Rebuttal of NYC MTA Platform Screen Door Feasibility study

Author: Joe Wu, PhD

- These slides will highlight some rebuttals for the NYC MTA's Platform Screen Door (PSD) feasibility study, which can be found at <https://www.mta.info/document/73241>. This report cites many reasons for why PSDs will not be feasible in the NYC subway system such as ADA non-compliance. Examples in the subsequent slides will show that MTA cherry picked data that support the ideas that PSDs are not feasible rather than making an effort to improve safety.

Figure 1 – Non-compliant ADA condition
Hoyt Street Station

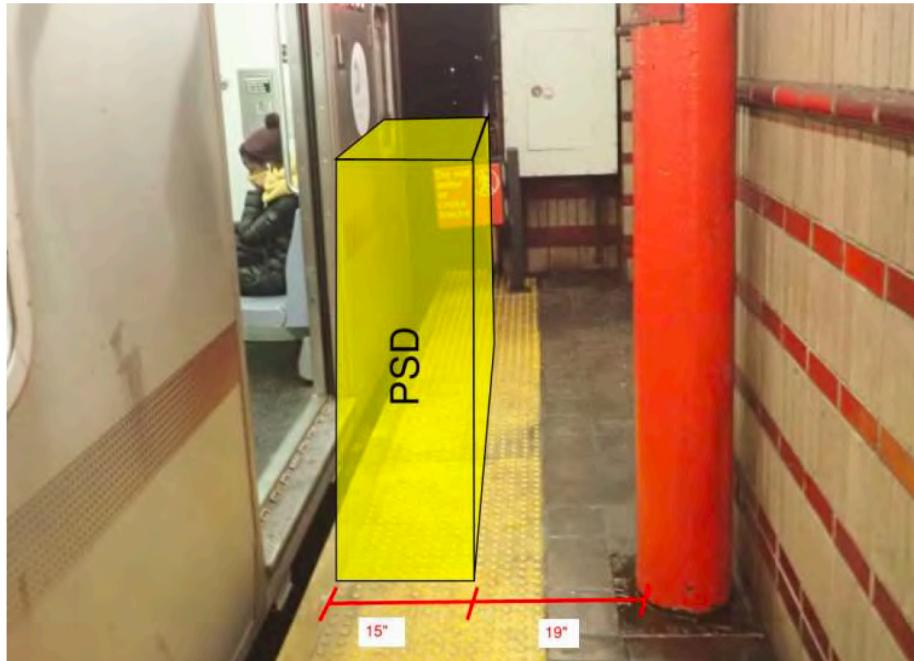
Hoyt street: ADA non-compliance (page 210)

- That section of the platform without the PSD is too narrow for normal passengers to stand or walk on, let alone someone in a wheel chair.
- The pipe is a big obstruction and safety concern as someone may walk on that section of the platform and around the pipe to wait for train effectively walking close to the platform edge.

Figure 1 – Non-compliant ADA condition
72nd Street Station

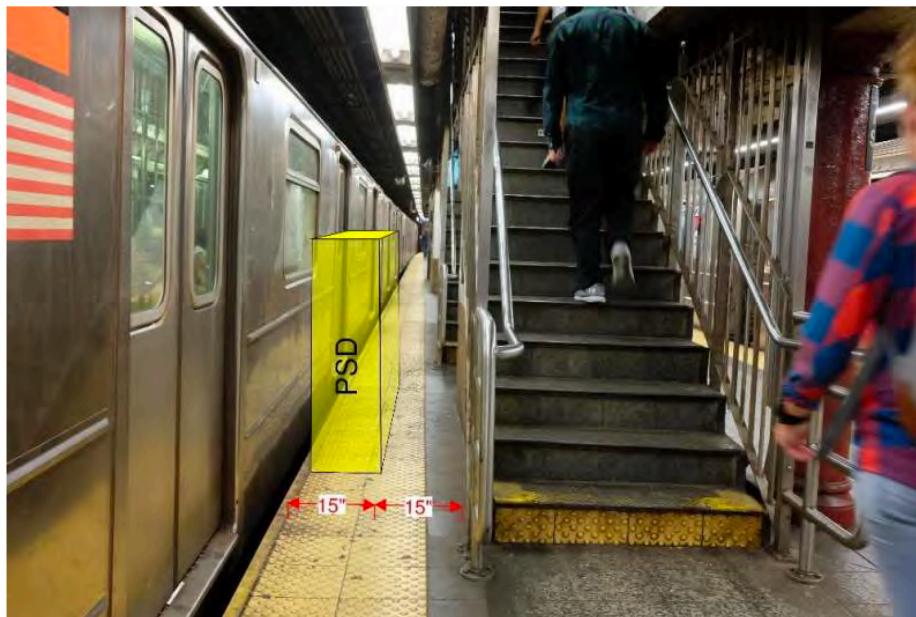
72nd street: ADA non-compliance (page 350)

- They cite 36 inches the minimum ADA requirement.
- At 30 inches (15+15) this section of the platform was not compliant with ADA in the first place and is too narrow for passenger traffic regardless of disability status. One foot will touch the yellow no-step line if someone were to walk through that strip of the platform, which goes against MTA's public safety announcement.
- A person in a wheel chair will not be descending to the platform using the stairs.
